# Land Use Review on the Western Part of Kennedy Town

Task Force on Harbourfront
Developments on Hong Kong Island
5.5.2015

規劃署
Planning Department

Current location of the arch and foundation stone adjacent to Sai Ning Street Bus Terminus

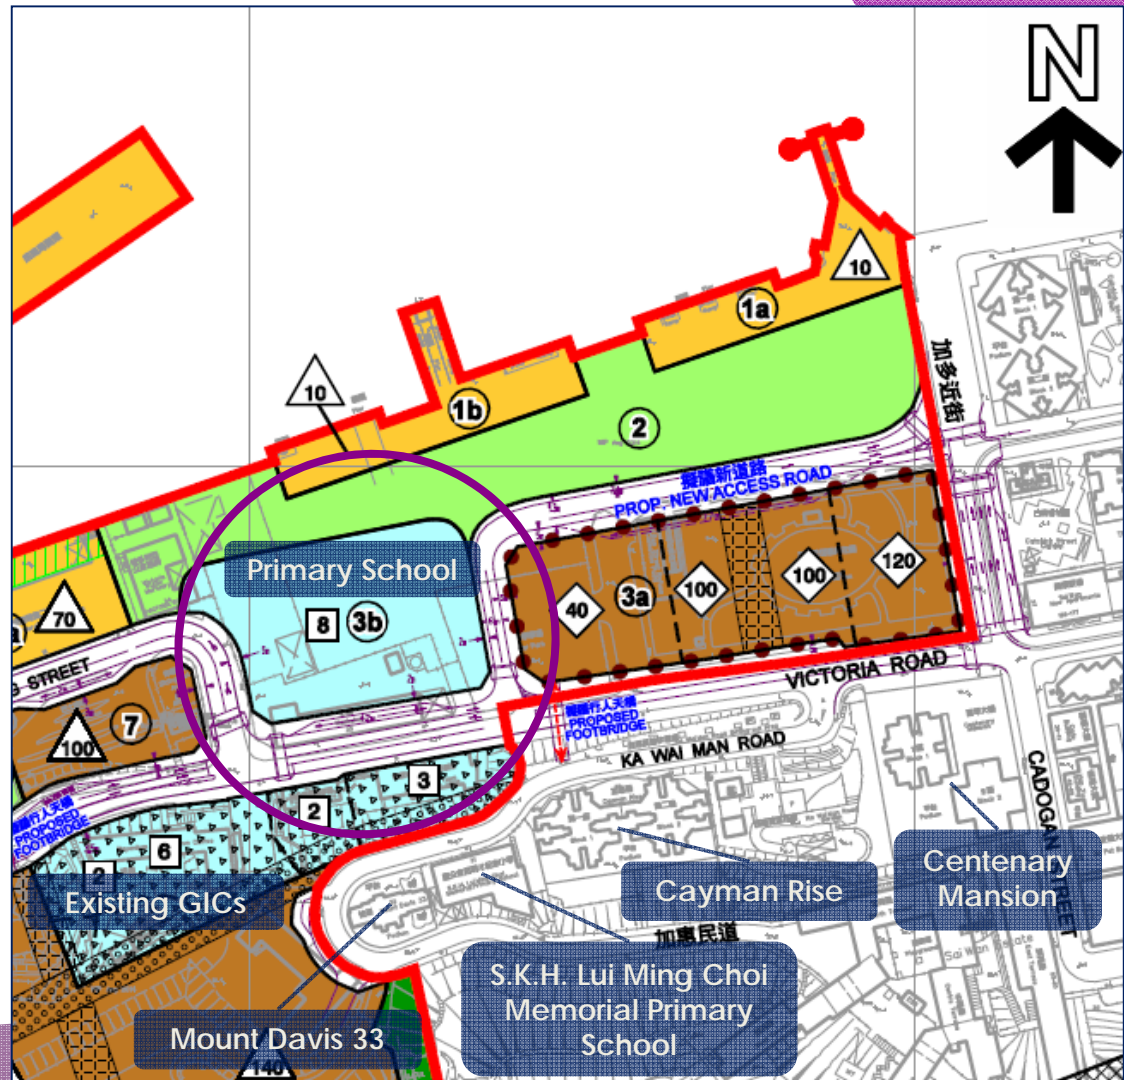
Others
- to retain the arch and foundation stone of the ex-Tung Wah Smallpox Hospital at its current location; and
- to extend tramway to serve new residential developments

- Relocation of the arch and foundation stone of the Ex-Tung Wah Smallpox Hospital to waterfront promenade for better setting for conservation

- TD has no plan to extend tramway service
